Whenuapai Wastewater Scheme – package 1 works

Meeting Notes and Actions

WHENUAPAI-REDHILLS WASTEWATER SERVICING PACKAGE 1
WASTEWATER PUMP STATION (DPISH)
EMERGENCY OVERFLOW PLAN & LONGITUDINAL SECTION

WHENUAPAI-REDHILLS WASTEWATER SERVICING PACKAGE 1
WASTEWATER PUMP STATION (DPISH)
EMERGENCY OVERFLOW - OUTFALL AND RIPRAP DETAIL

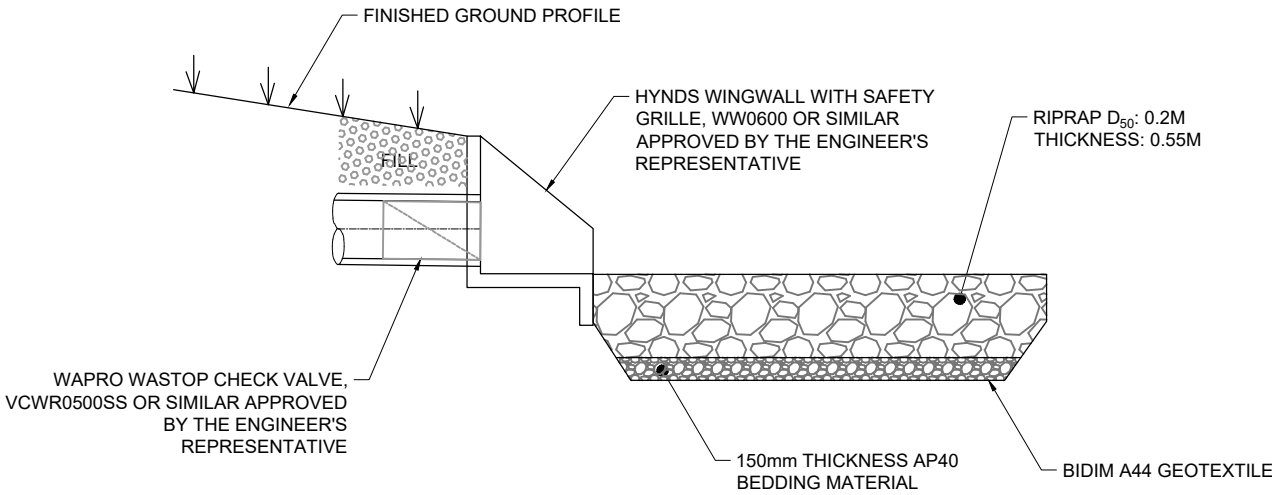
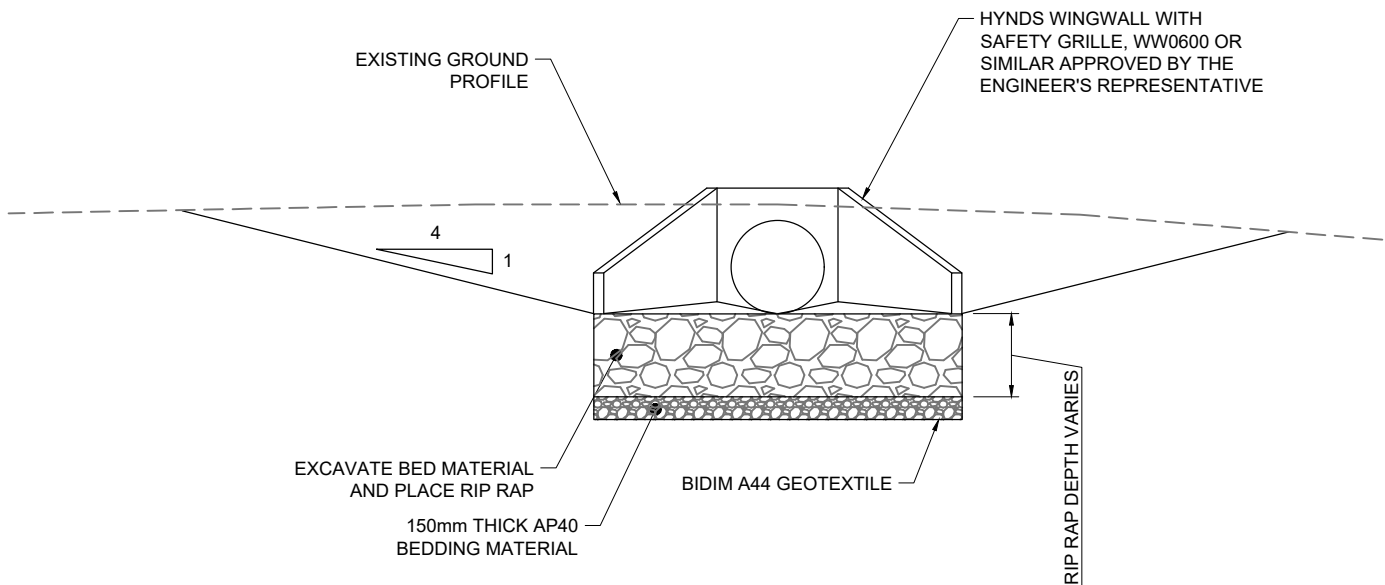
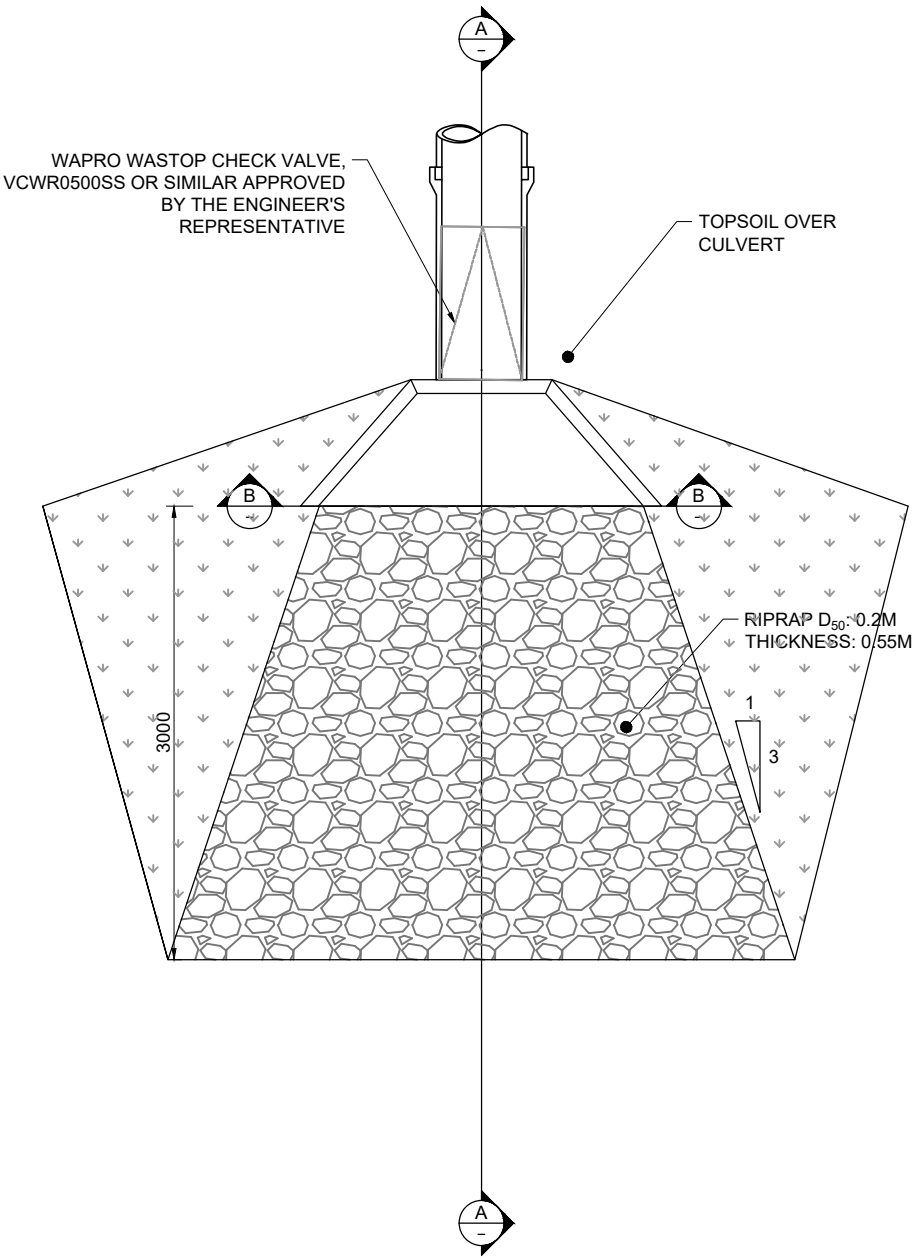
- EMERGENCY OVERFLOW PLAN & LONGITUDINAL SECTION as per drawing 2013646.012
- EMERGENCY OVERFLOW - OUTFALL AND RIPRAP DETAIL as per drawing 2013646.013

As detailed in the application information sheet, the requirements of this approval include the following:

- i. Telemetry is required on all new EOPs and is expected to be live.
- ii. Healthy Waters will be provided with this live information covering overflow occurrences, timeframe of occurrences and any other relevant telemetry information Watercare has on the EOP.
- iii. The EOP connection is expected to display in the Council GIS system within 30 days of construction completion
- iv. Clean up of overflows shall be the responsibility of Watercare to the satisfaction of the HW area operations manager.
- v. Where the overflow extends to private watercourses or other open environments, Watercare will manage the effects and respond to any complaints.
- vi. Screening is to be installed on overflow weirs to mitigate debris where possible.
